# PERMIT

SEWAGE DISPOSAL SYSTEM  
HOWARD COUNTY HEALTH DEPARTMENT  
BUREAU OF ENVIRONMENTAL HEALTH  
410-313-2640

A REPAIR

SUBDIVISION Patapsco Park ~~SEWERS~~ LOT NUMBER 22 ADDRESS 9080 Furrow Avenue

EXPANDED VIEW

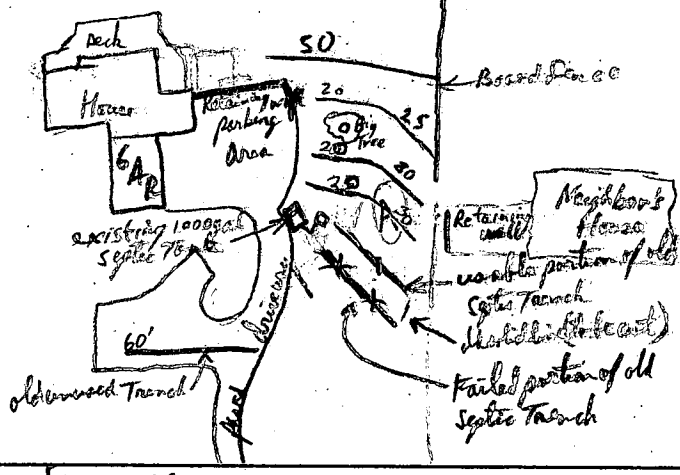
INSPECTION COMMENTS: Old Trench extended to 40 ft long (OK to cover), db cut, New PVC outlet Baffle installed in S.T.

Started digging second Trench (First New Trench) Reopen digging slow due to Frozen Ground (10" freeze) + Tight Space, OK to proceed. RP 1/4/01 Dirt Box Marked by clean cut pipe, 2nd + 3rd Trenches gravelled, piped, covered, and OK to cover. Call for More Imp. Transducer. 1/4/01 RP

1/5/01 1:00 OK, CONTINUE 1/5/01 3:00 OK, FINISH + COVER
